WARRANTY
CAMPAIGN

ROADSTER
WARRANTY
Bulletin

Campaign no.: 2013-0015
2013-0016

Subject: **Spyder™**

A - Replace Fuse Box Covers

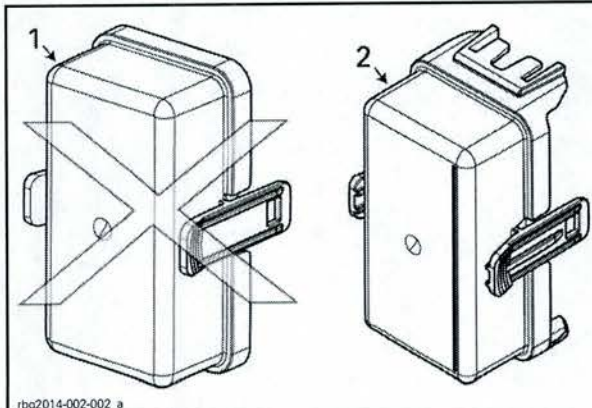
1. Old fuse box cover
2. New fuse box cover

1. Remove old covers.

2. Transfer fuses to new covers.

1. Replace the fuse box covers.
2. Apply liquid tape around base of bus-bar.
3. Apply liquid tape into and around all splices behind fuse boxes.

A - Seal Wire Splices Behind Fuse Box

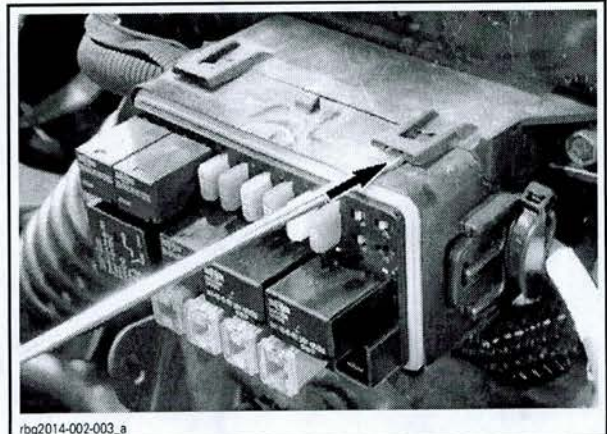
1. Carefully unclip a fuse box.

TYPICAL LIQUID TAPE APPLICATION

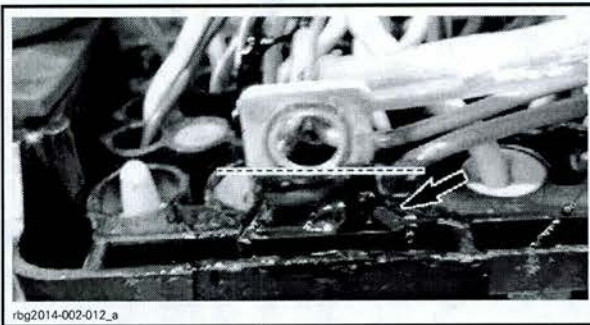
4. Remove electrical tape as needed to expose all wire splices behind the fuse box.
5. Seal both ends of all the wire splices with liquid tape.

NOTE: Extend liquid tape onto wires and push the liquid tape into both ends of the splice for a good seal.
